**Play Field Turf Replacement  
Mission High School #11814**

**ADDENDUM NO. 1**

**PROJECT:** Mission High School  
3750 18<sup>th</sup> Street  
San Francisco, 94114

**DATE:** 5 May 2016

MIDFIELD LOGO

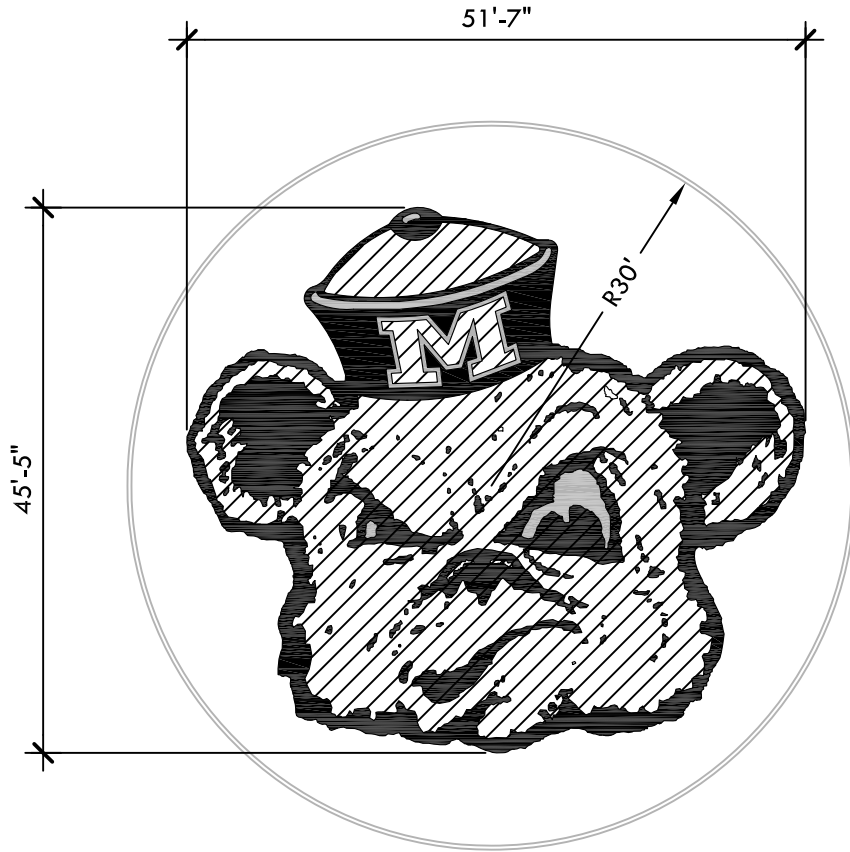
Construction Details, Sheet D3.0. **CHANGE:** Midfield Logo, Detail G, has been updated per new Mission High School Logo. Refer to Drawing Attachment #1 for additional information.
